Architects Supplemental Instruction (ASI)

Project: West Birch Apartments and Townhomes	ASI #: 01
Owner: West Birch Estates of Princeton	Date of Issuance: 09/26/19
To: Lumber One Avon	Architect's project #: 616-18

The intent of this ASI is to amend the Project Documents to incorporate various VE items which were unintentionally omitted in previous document revisions. It is not expected that any of the included items will have any impact on current Project Pricing.

2 UNIT TYPE C - 2 BED 1 BATH
1/4" = 1'-0"

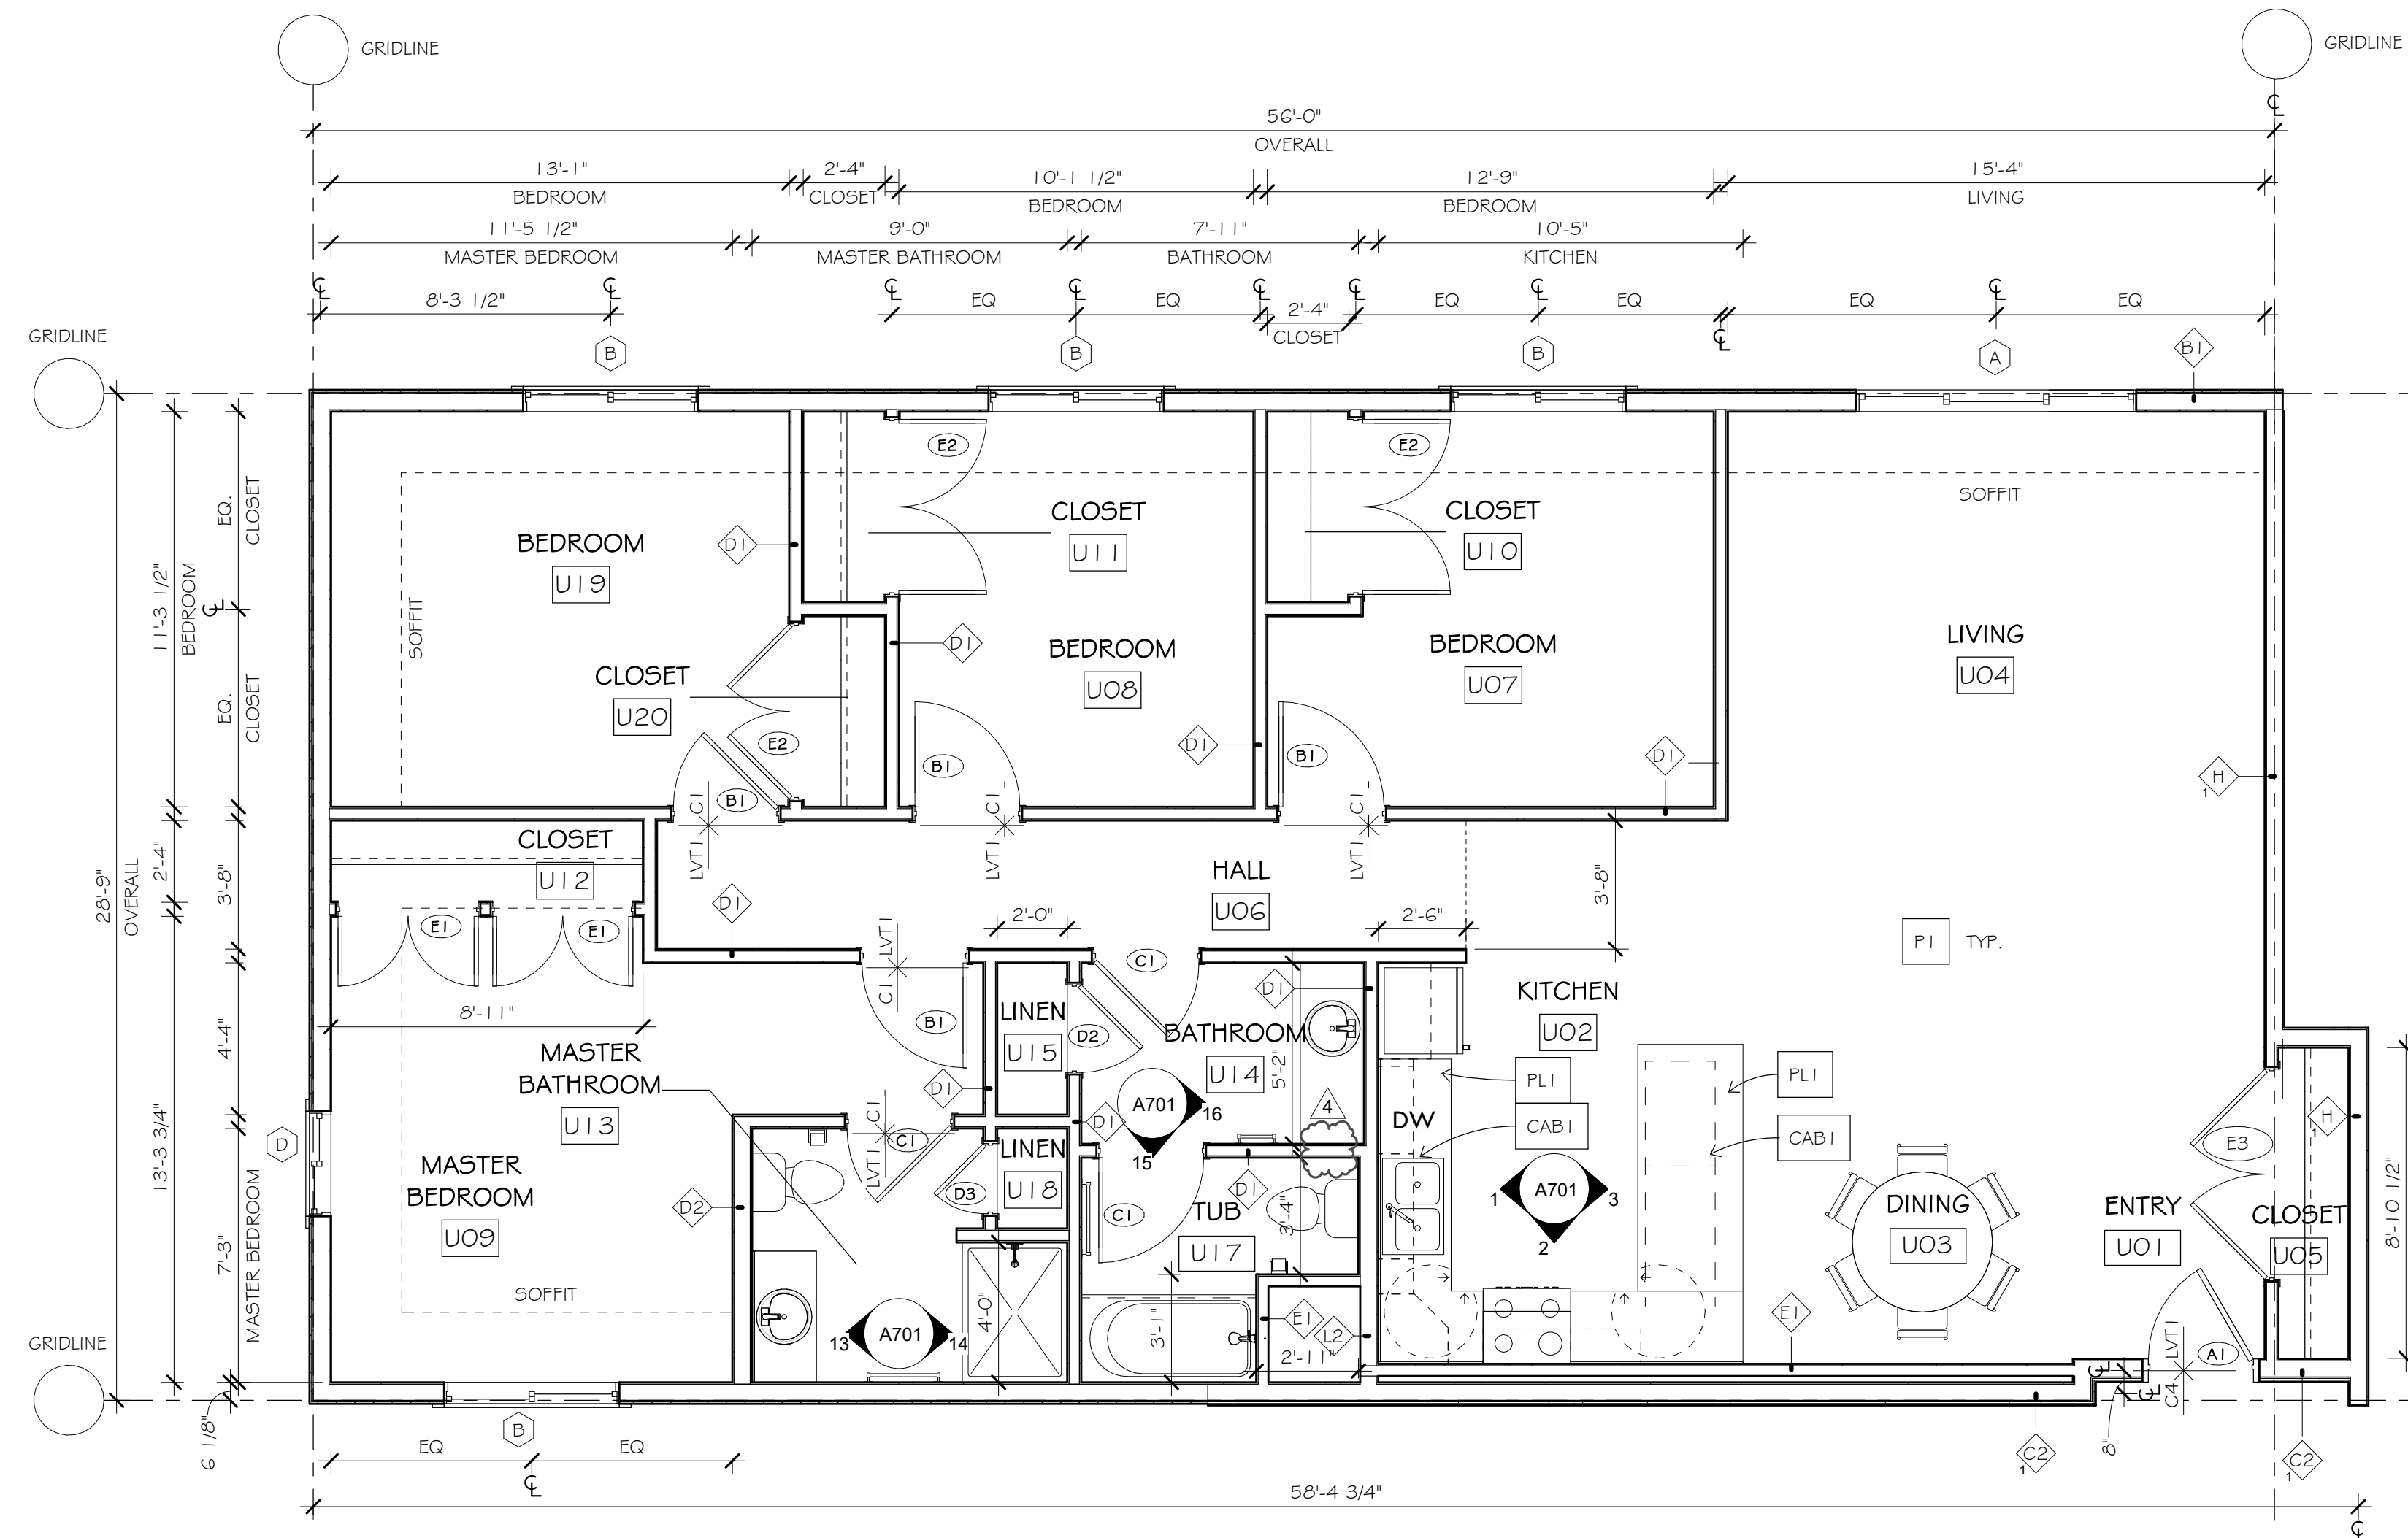
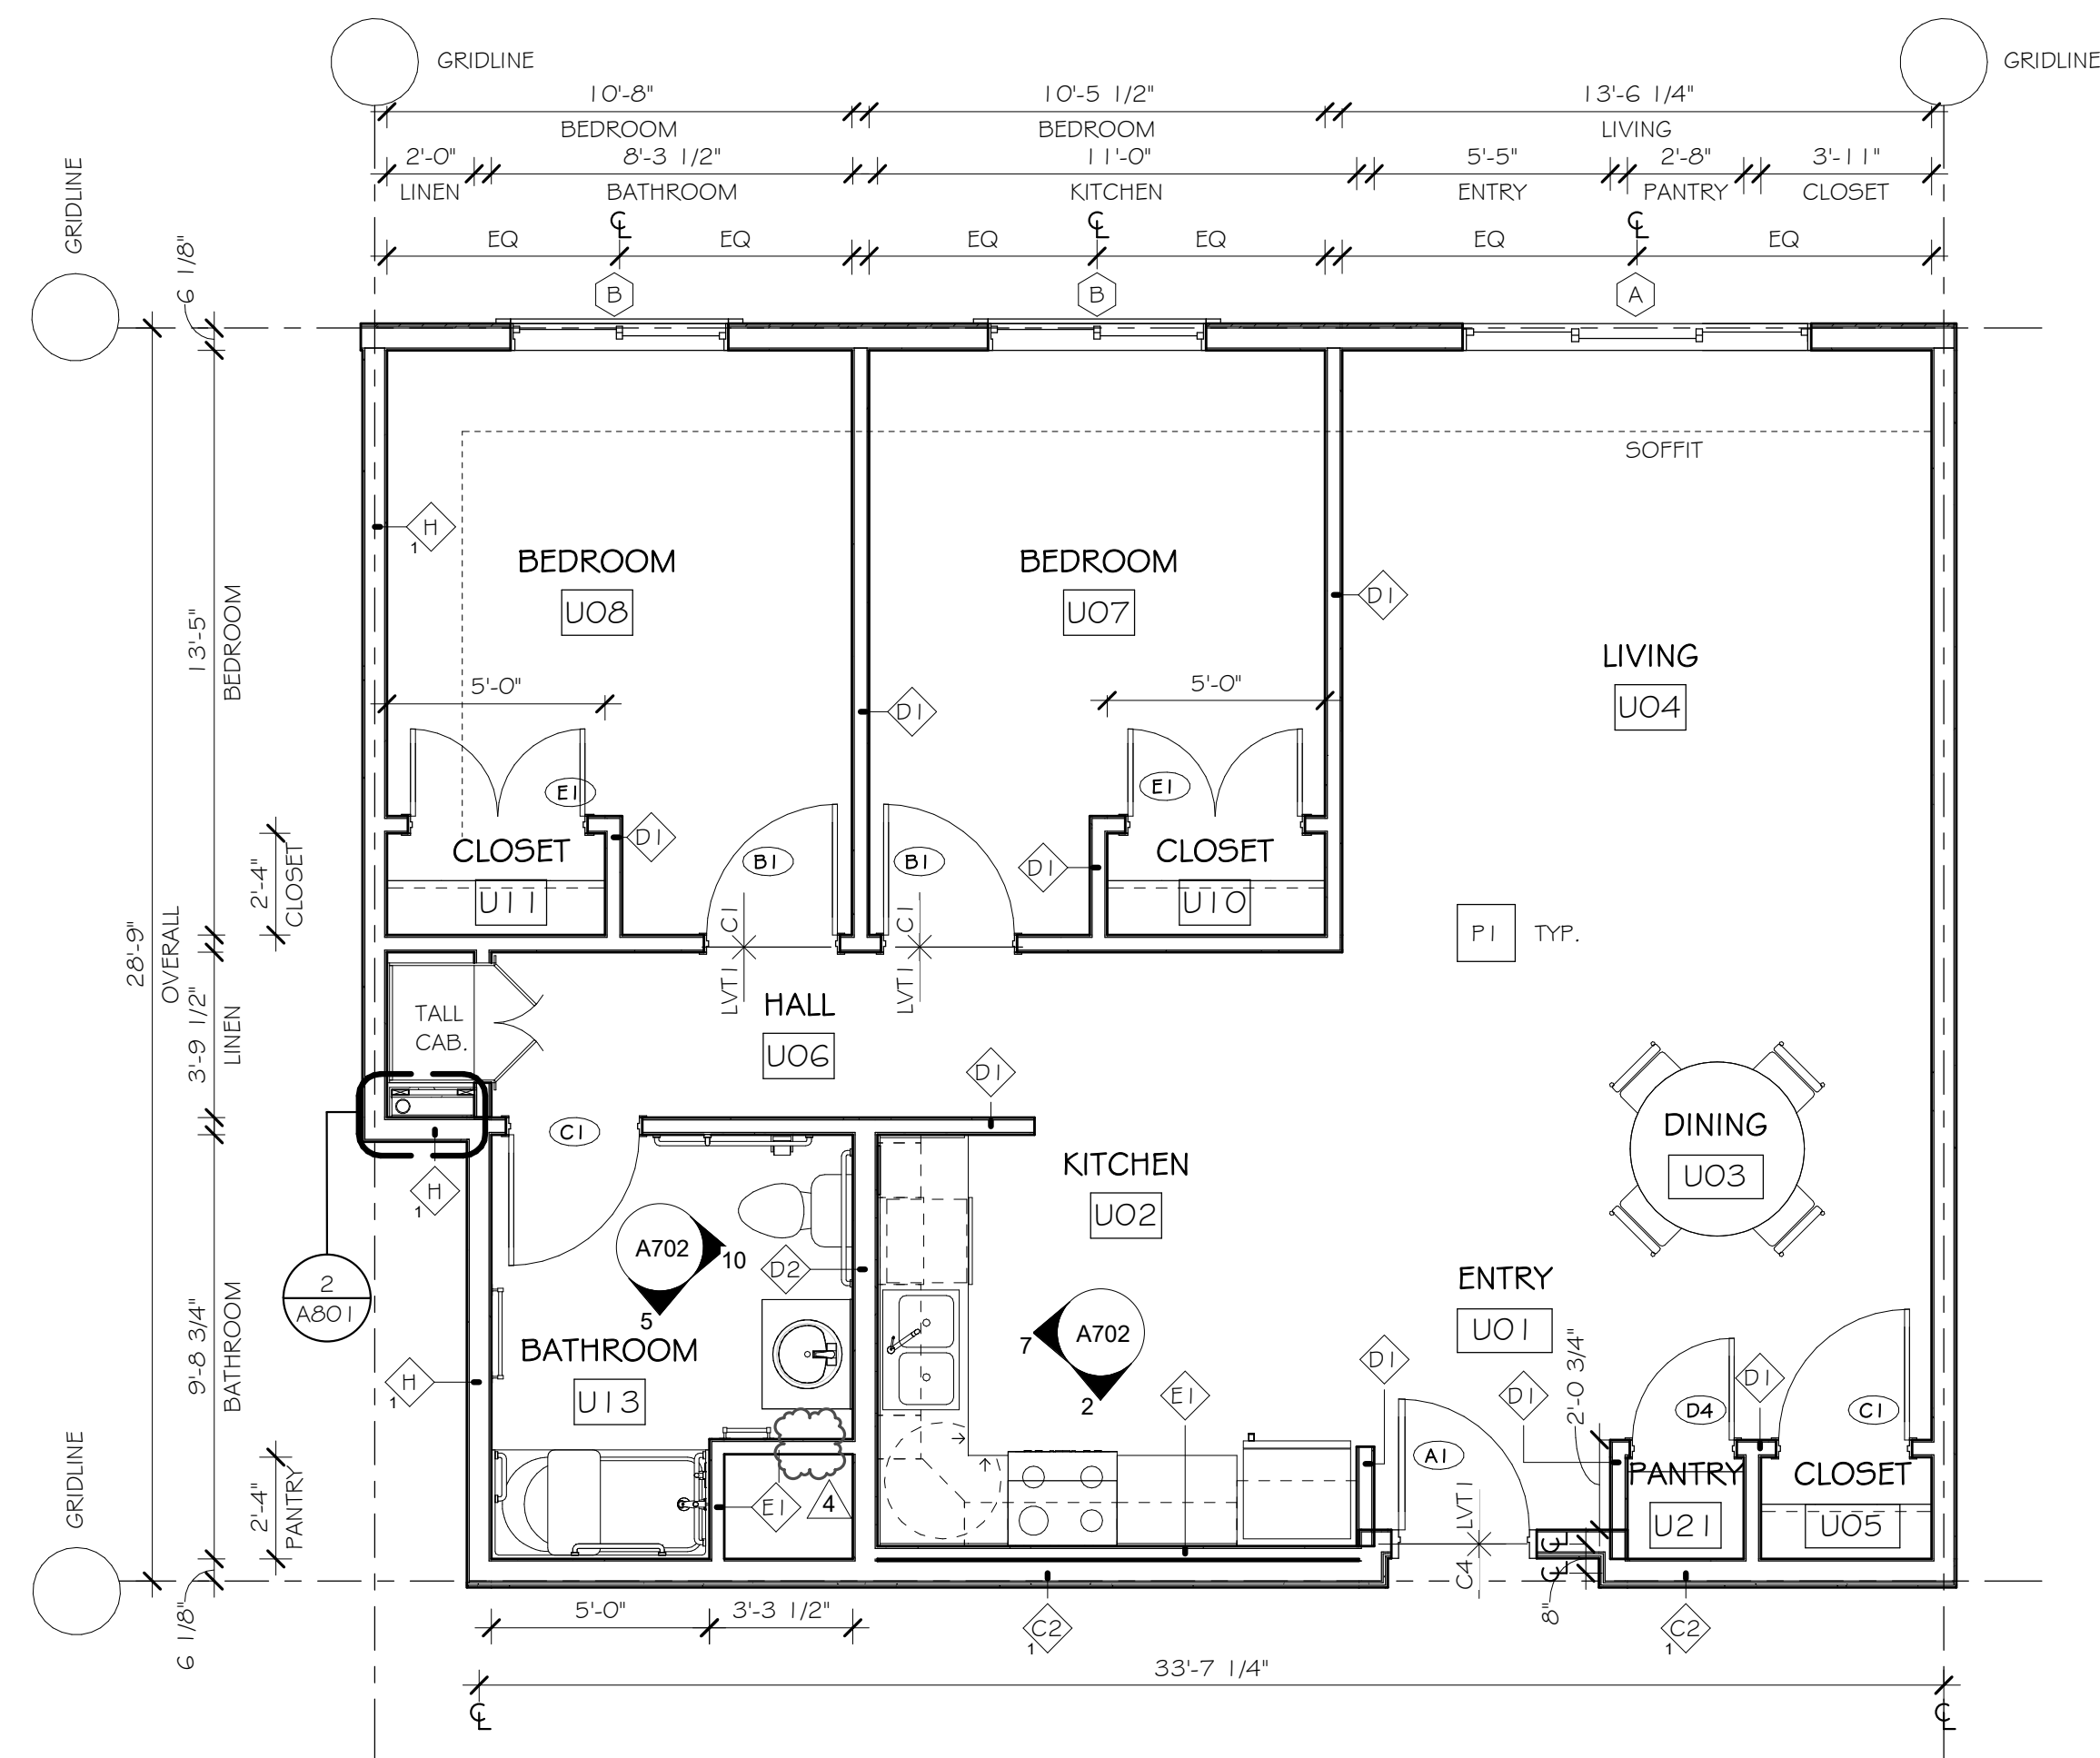
1. Removed text notes referring to cellular PVC trim and replaced them with text notes referring to steel clad trim. Refer to the following sheets (Attached):
 - a. Sheet A310 – Wall Section – detail 2/A310
 - b. Sheet A602 – Exterior Details – Detail 3/A602
 - c. Sheet A603 – Exterior Details at Openings – 2/A603, 4/603
2. Removed medicine cabinets. Refer to the following sheets (Attached):
 - a. Sheet A410 – Enlarged Plans – Unit Types A, A.1, B, & F - Detail 1/A410, 2/A410, 3/A410
 - b. Sheet A411 - Enlarged Plans – Unit Types C, C.1 & D – 1/A411, 2/A411
 - c. Sheet A412 - Enlarged Plans – Unit Types E (ACC) & C.2 (ACC) – 2/A412, 4/A412
